STATE OF DELAWARE
DEPARTMENT OF TRANSPORTATION
800 BAY ROAD
P.O. BOX 778
DOVER, DELAWARE 19903

April 18, 2016

RE: Agreement No. 1655
Traffic Impact Study Services
Task No. 1 Subtask 15A – Love Creek Elementary School

McCormick Taylor has completed its review of the Traffic Impact Study (TIS) for the Love Creek Elementary School prepared by Davis, Bowen & Friedel, Inc. (DBF), dated January 2016. This review was assigned as Task Number 1 (Subtask 15A). DBF prepared the report in a manner generally consistent with DelDOT's *Development Coordination Manual*.

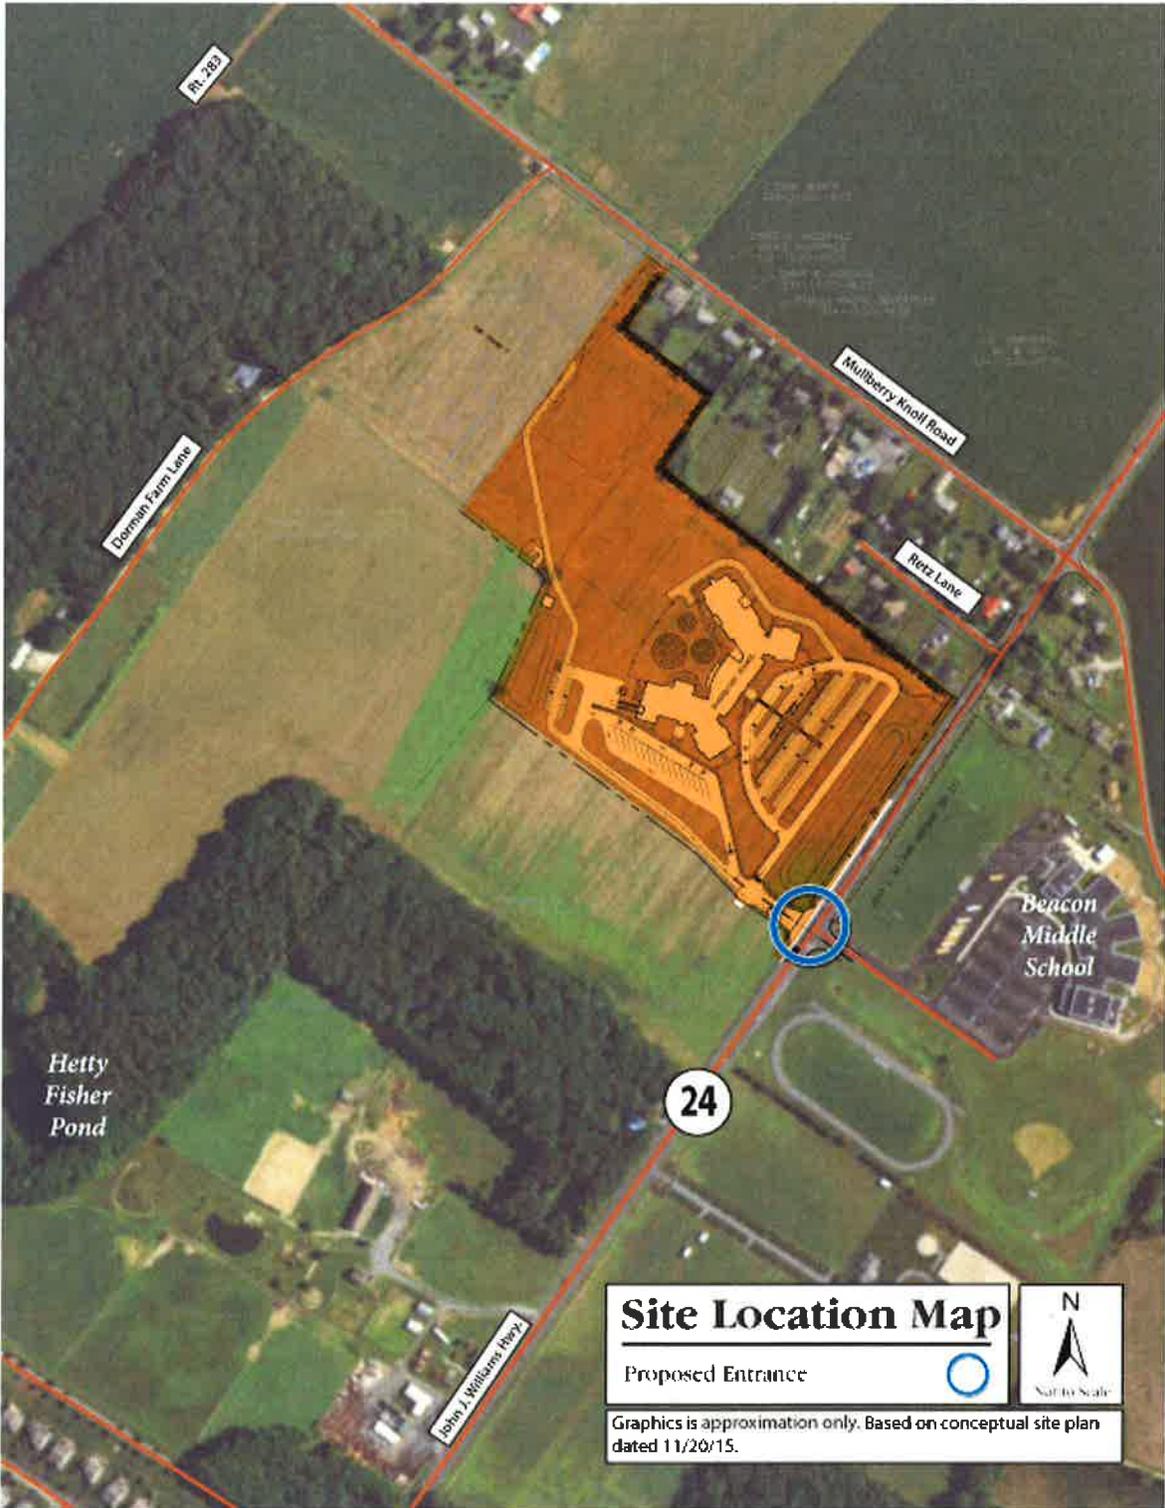
Location: The LCES is proposed to be located on the west side of Delaware Route 24 (John J. Williams Highway / Sussex Road 24), just south of Mulberry Knoll Road (Sussex Road 284) in Sussex County, Delaware. A site location map is included on Page 10.
